# Access Compliance Report

## Public Rights-of-Way

Intersection ID: 5162	Main Street: BROOKFIELD_POINTE_DR	Cross Street: SUNSET_RD	Location: S
ADA ID: AE8CA1550449	Ramp Type: PerpDiag	Initial Pass/Fail: Fail	Overall Compliance: No
Codes/Mitigation Info/Possible Solution		Field Measurements/Component Compliance

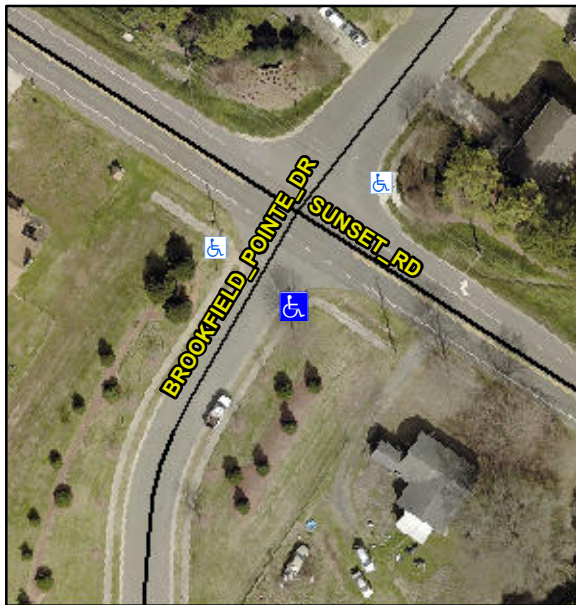
**Not Found, R304.5.1, R304.5.3**

Compliance	Description	Data	Compliance	Description	Data
N/A	Ramp Length (in)	48.5	Yes	Ramp Slope (%)	6.5
No	Ramp Width (in)	41.0	No	Ramp XSlope (%)	3.0
N/A	Flare Type LT	N/A	N/A	Flare Type RT	N/A
N/A	Flare Slope LT (%)	N/A	N/A	Flare Slope RT (%)	N/A
N/A	Flare Traversable LT?	N/A	N/A	Flare Traversable RT?	N/A
N/A	Landing Length (in)	N/A	N/A	DWS Provided?	N/A
N/A	Landing Width (in)	N/A	N/A	DWS Contrast?	N/A
N/A	Landing Slope (%)	N/A	N/A	DWS Length (in)	N/A
N/A	Landing X Slope (%)	N/A	N/A	DWS Full Width?	N/A
N/A	Landing Curb? (Y/N)	N/A	N/A	DWS Offset (in)	N/A
N/A	Shared Landing?	N/A			
N/A	Gutter Ponding?	N/A	N/A	Gutter Slope (%)	N/A
N/A	Gutter Lip Ht (in)	N/A	N/A	Gutter X Slope (%)	N/A
N/A	Painted X Walk1?	No	N/A	Painted X Walk2?	No
	X Walk 1 Direction	To NE		X Walk 2 Direction	To NW
N/A	X Walk 1 Width (in)	N/A	N/A	X Walk 2 Width (in)	N/A
	X Walk 1 Slope (%)	6.9		X Walk 2 Slope (%)	2.5
	X Walk 1 X Slope (%)	1.6		X Walk 2 X Slope (%)	4.3

**Remove & Replace Curb Ramp With Two New Directional Ramps or Equivalent.**
